Board of Mayor and Aldermen
July 2, 2024 Regular Meeting @ 7:00 PM

Item #: 8.C. Approve Change Order #3 with Baron Construction, LLC for the Public Works and Community Development Services Facility.

This is a change order for the construction of the Public Works and Community Development Services Facility.

E303

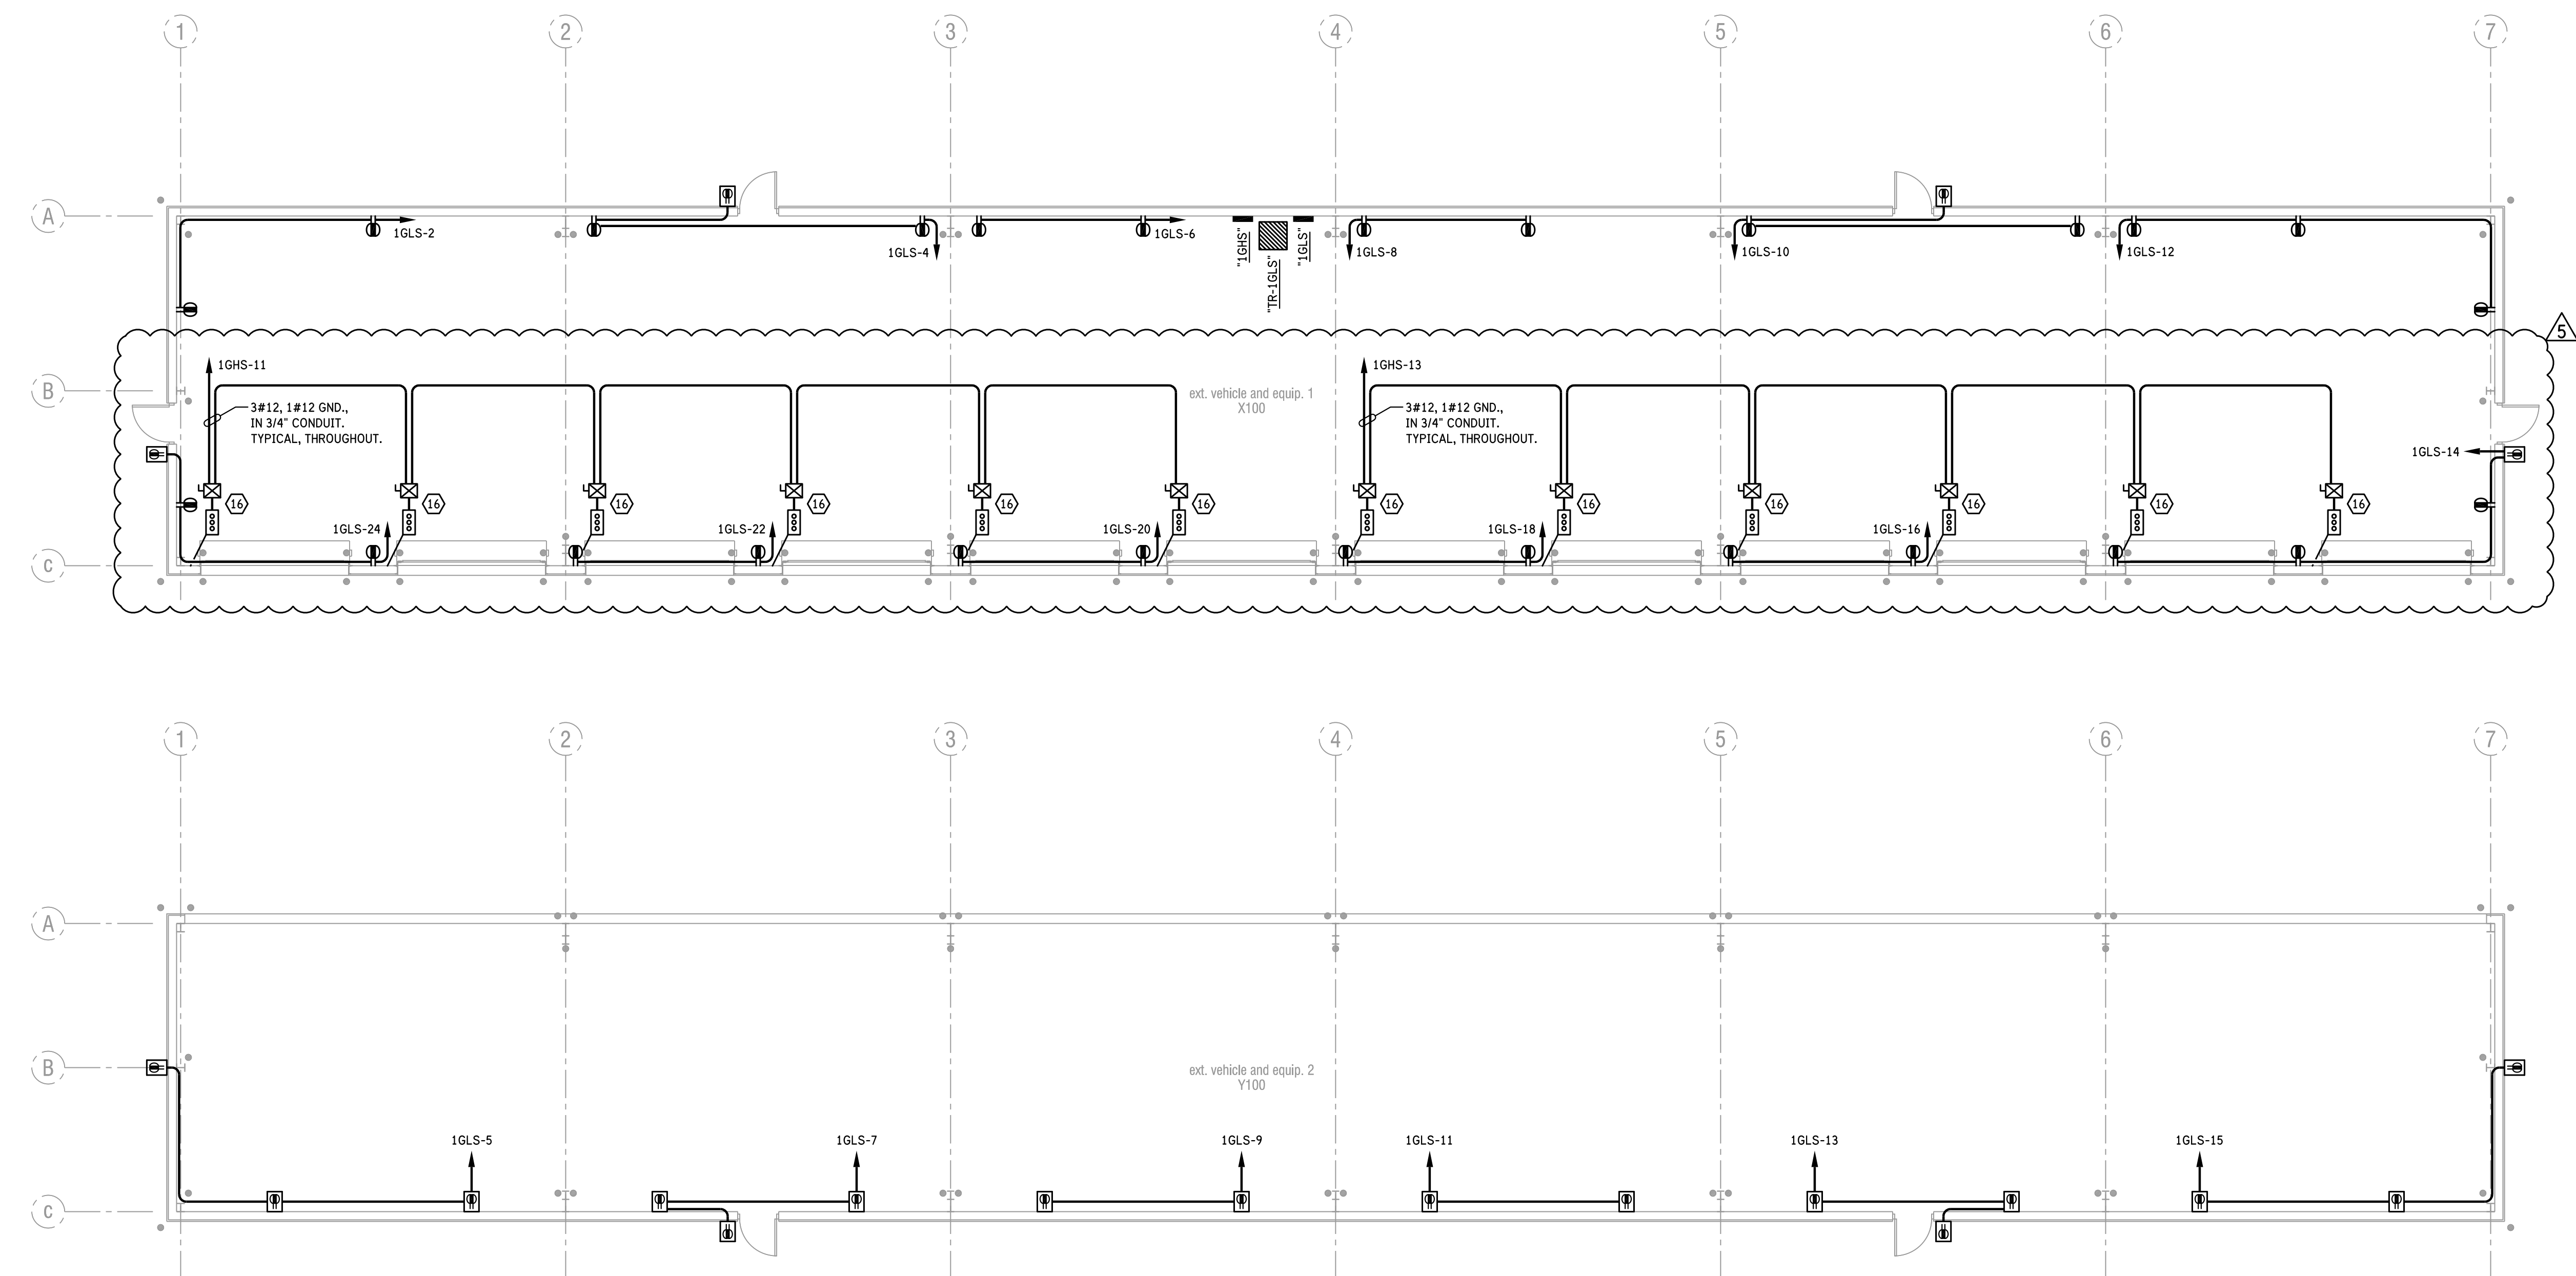
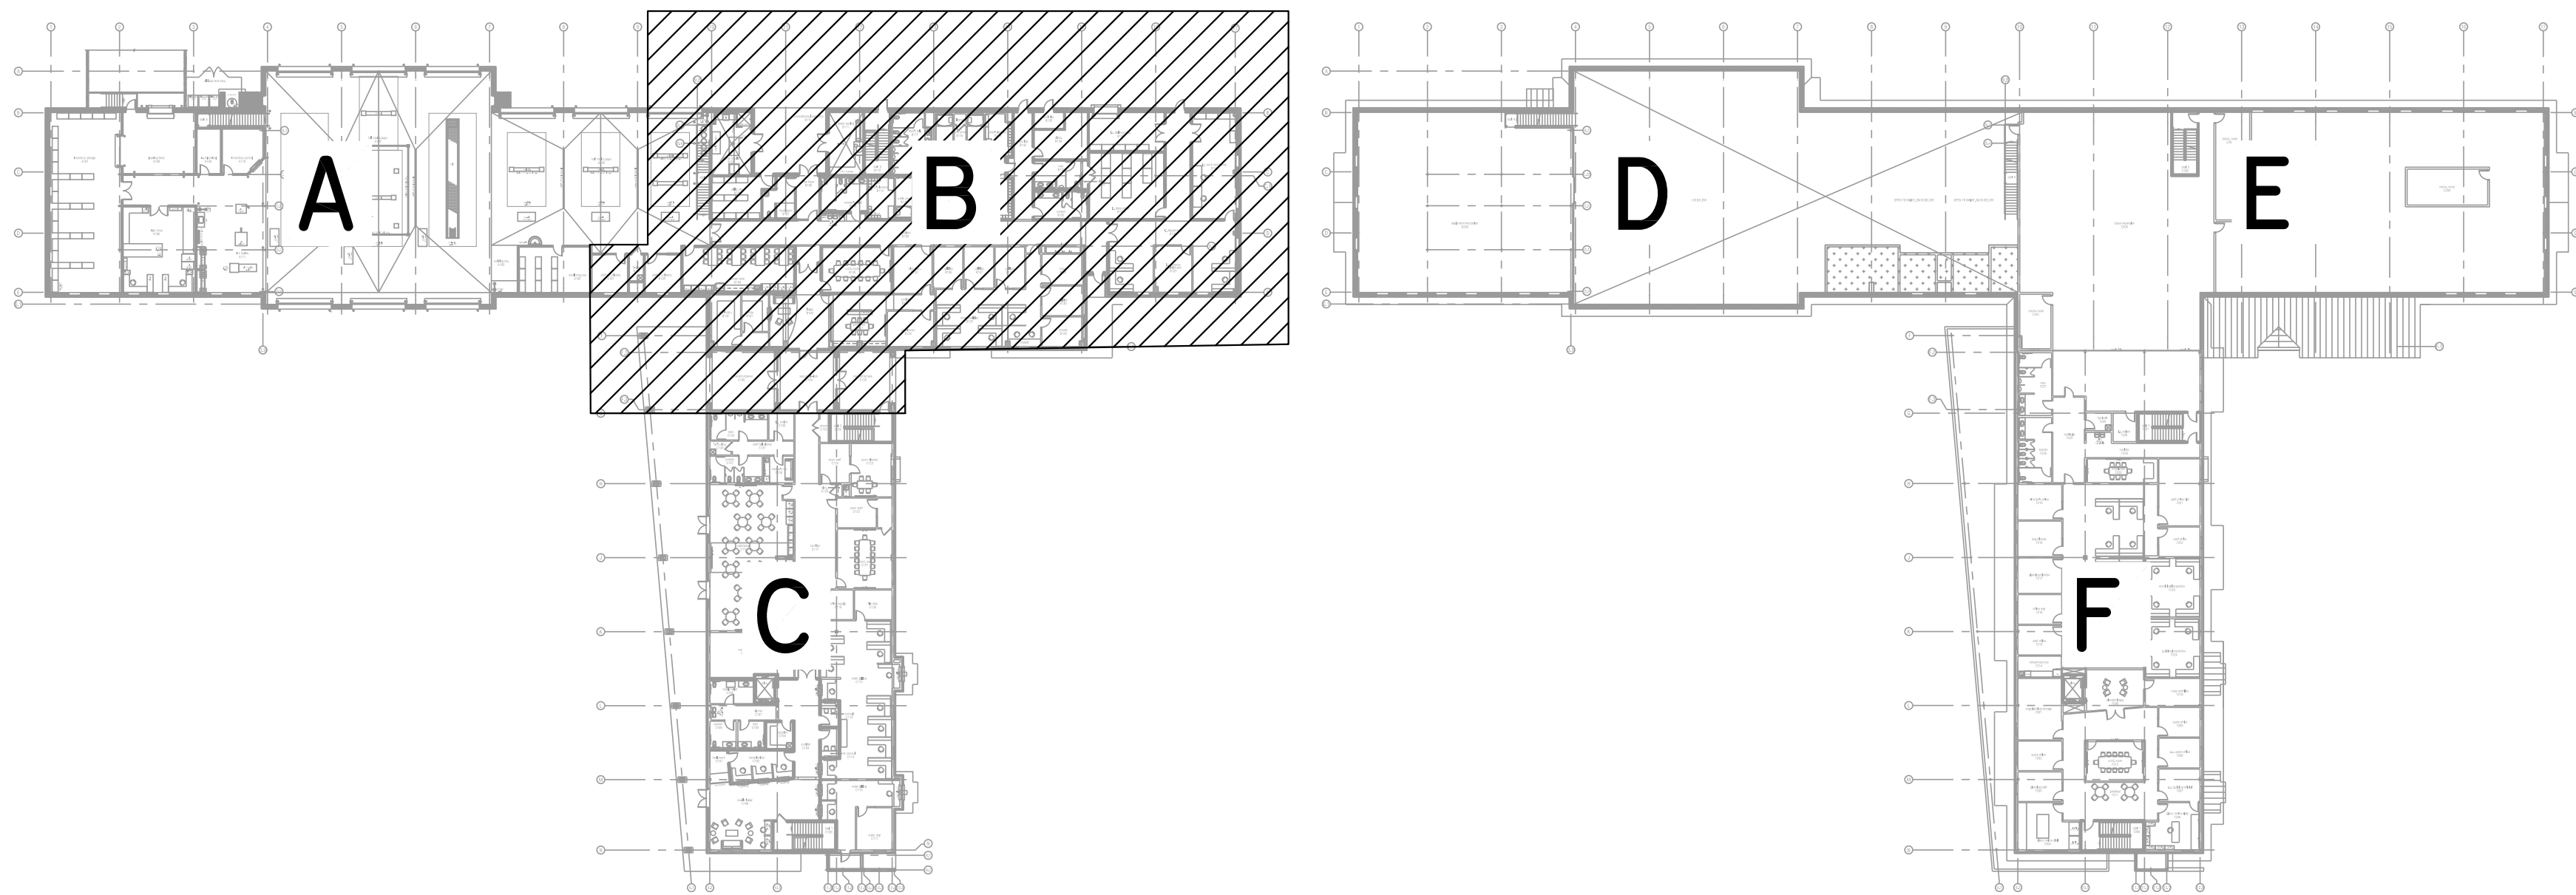
Question	Question from Roy Bruce Baron Construction, LLC on Thursday, Mar 21, 2024 at 02:18 PM CDT Tyler, The electrical drawings do not show power/circuits for the overhead doors at Exterior Vehicle Bldg 1 (sheet E308). Can you please send over a drawing showing the design intent for this? Also, per previous email correspondence can we please get a revised drawing(s) for Area A showing the circuits for the two overhead doors at Loading Dock A108 area (sheet E302). Attachments RE_ La Vergne PW - Dock Levelers _ Electrical Clarification.pdf
Official Response	Response from Tyler Ball Harpeth Park Engineering PLLC on Wednesday, Apr 3, 2024 at 09:27 AM CDT See attached revised drawings concerning the overhead doors. Narrative of changes: E302 Added overhead door connection for Inventory Storage A107. Revised overhead door connection in Loading Dock A108 for clarification. Edited Keyed Note 16 for clarification. E303 Revised overhead door connection in I.T. Delivery/Storage B139 for clarification. E308 Added overhead door connections for the Exterior Vehicle and Equipment 1 X100 shed. E702 Revised panel schedules per overhead door connections. Attachments E302 (ESD #5).pdf, E702 (ESD #5).pdf, E303 (ESD #5).pdf, E308 (ESD #5).pdf

E303 Revised overhead door connection in I.T. Delivery/Storage B139 for clarification.

9A

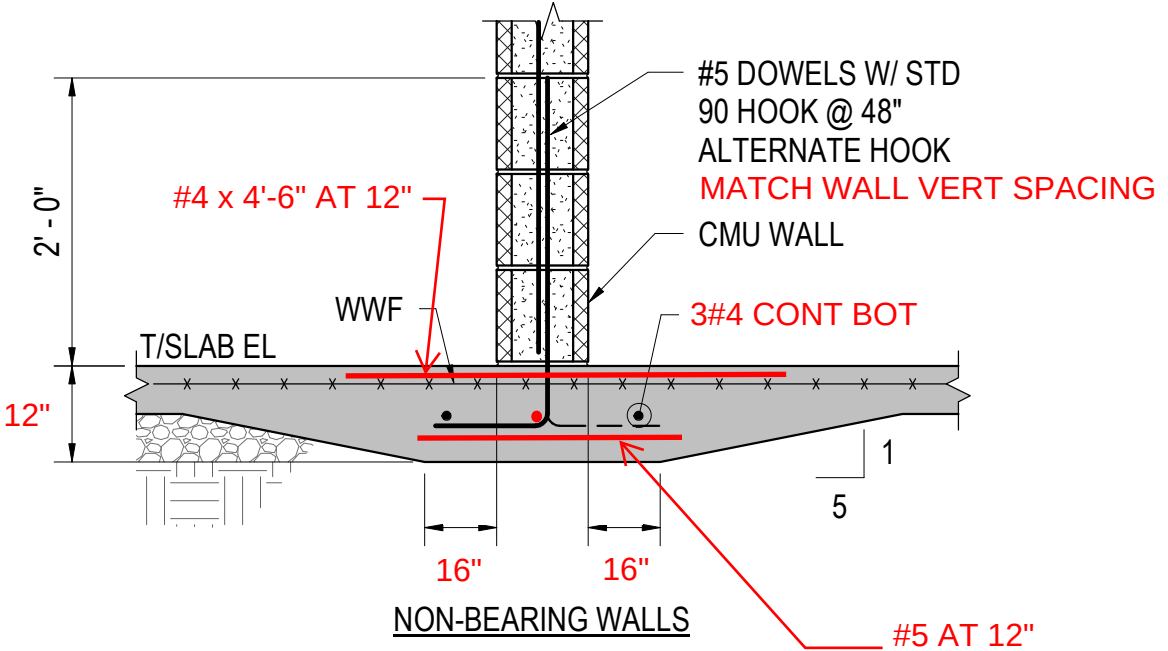
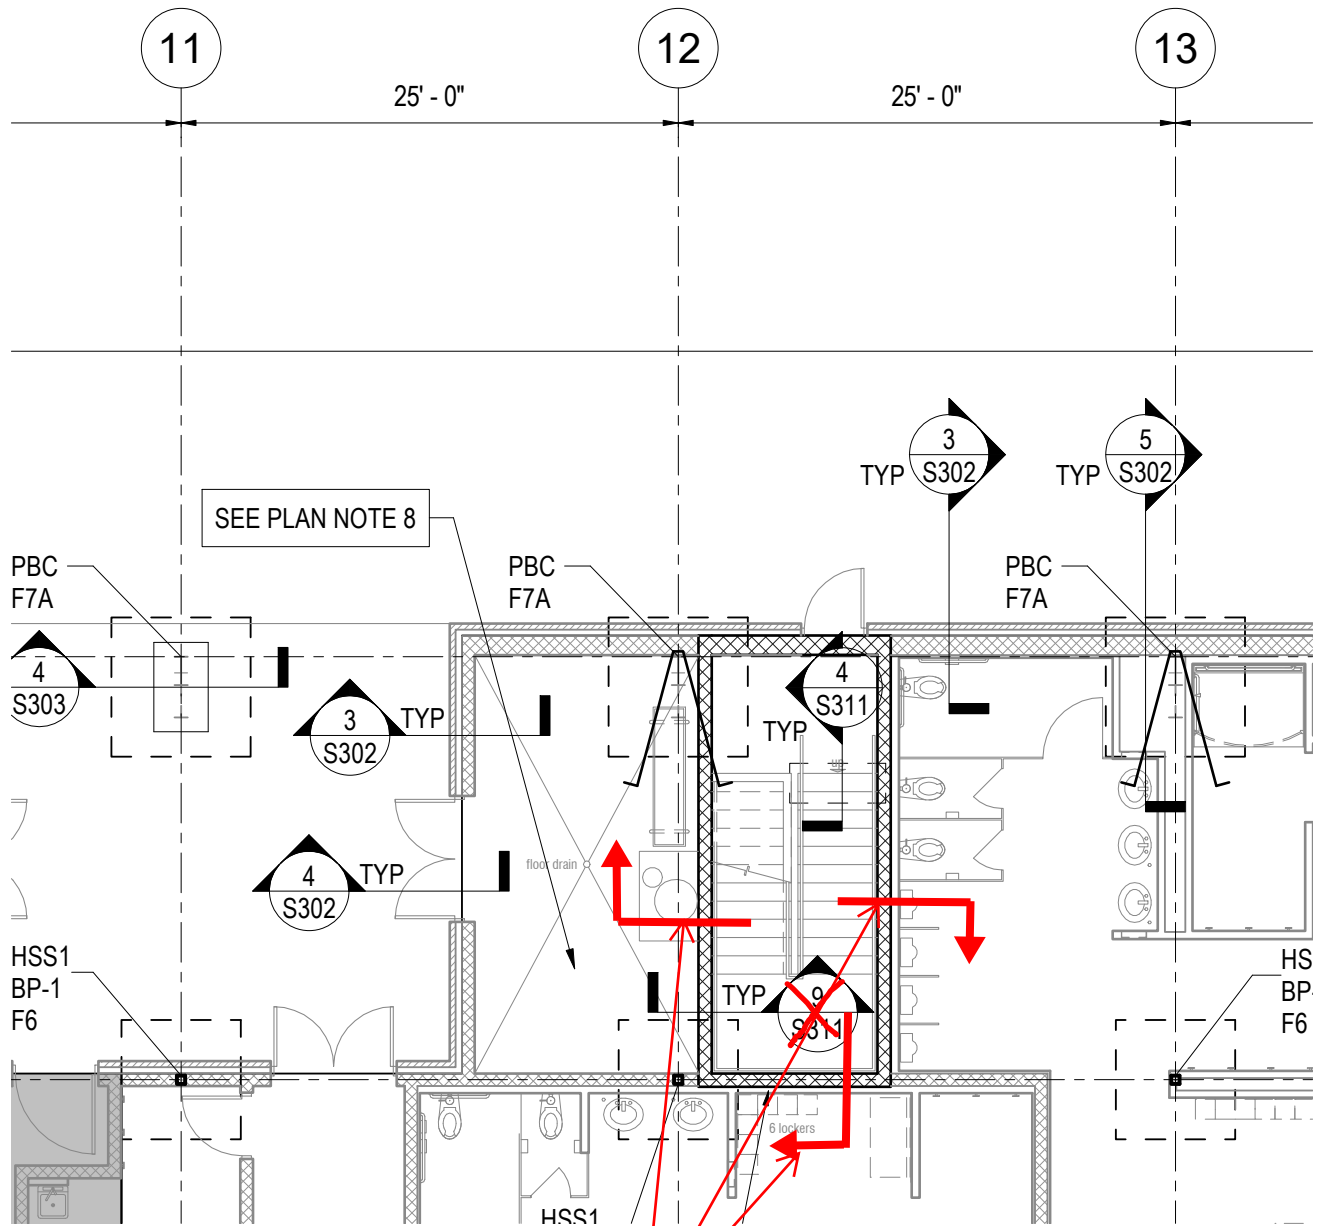
35	Footing modification at Stair 3 for CMU walls per Engineers instruction. Two story CMU walls that support the landing, requiring thickened slab detail modification at these CMU walls	\$1,620.09	
38	Credit for TTL Reinspection Costs per Contracts Letter C-003 received via email from Gary Lide. Attached summary marked up to remove items not agreed to by Baron Construction	(\$6,343.00)	
		\$83,861.04	19

From: David Lower <david.lower@wallace.design>
Sent: Thursday, April 18, 2024 10:31 AM
To: Roy Bruce
Cc: dylan.jenkins@wallace.design; Annie Flanagin; JB Nease; com-inbound-city-of-la-vergne-public-works--community-developm@procoretech.com
Subject: Re: La Vergne Public Works - footer conflict
Attachments: CMU Wall Plan 4-18-2024.pdf; Detail 9A.pdf

PROVIDE W1.7 WIRE REINF AT 16" O.C. HORIZ MAX
